Public Input No. 25-NFPA 20-2022 [Global Input]

Statement of Problem and Substantiation for Public Input

Figure A.4.16.4 Schematic Diagram of Suggested Arrangements for a Fire Pump with a Bypass, Taking Suction from Public Mains.

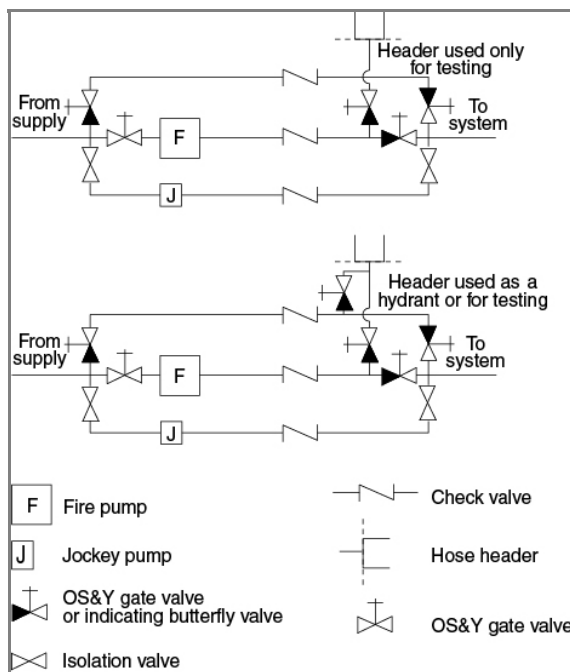
Fire Pump Diagram should be more detailed to provide guidance for designers and field installation. We suggest referencing A8.5.2 (A) in NFPA 20 as a guide as well as A7.1 (A)-(C) in NFPA 14.

NFPA 20 currently does not show a very detailed pump room layout. Improving this detail will help designers/field techs/etc. have more clarity on how to lay out the pump room and leave a smaller room for mistakes.

Figure A.10.8 Typical Fire Pump Controller and Transfer Switch Arrangements.

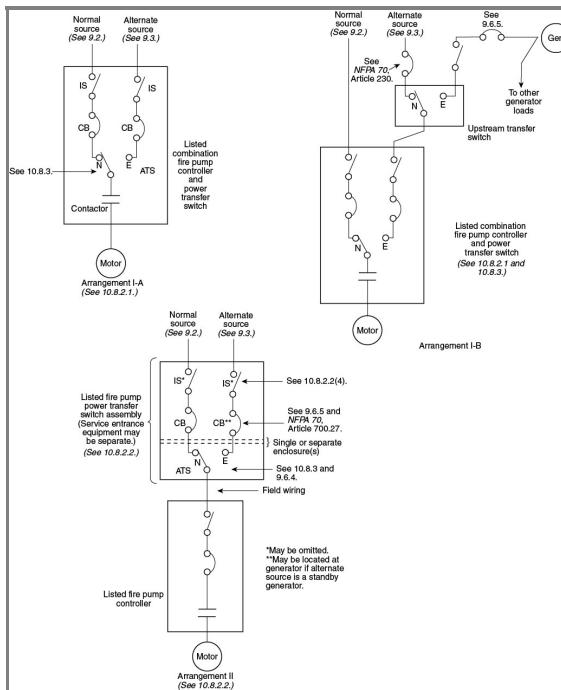
Change under "Motor" Arrangement 1-A- in first diagram to 1. (remove the A)

Figure A.10.10 Variable Speed Pressure Limiting Control.

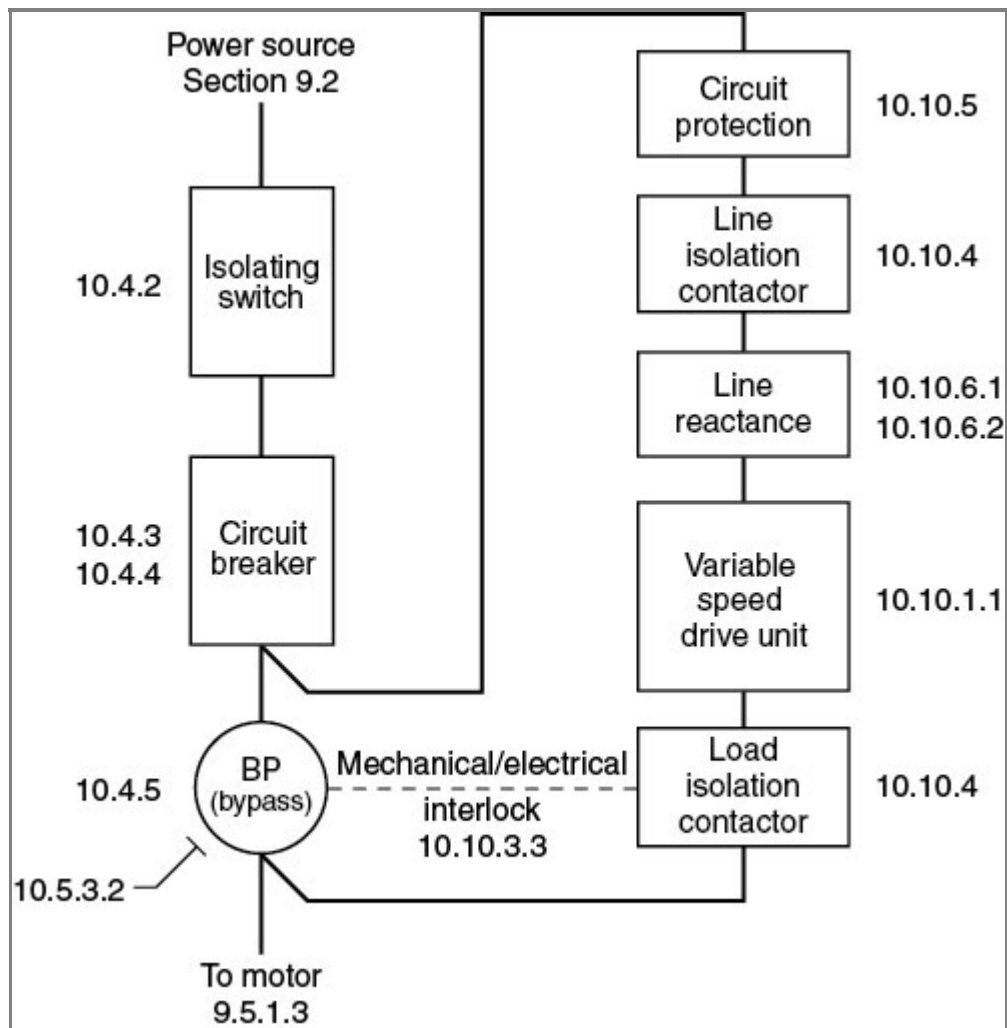
(Change reference 9.5.1.3 to 9.5.1.4)

Statement: This revision corrects cross references in Figure A.10.10.
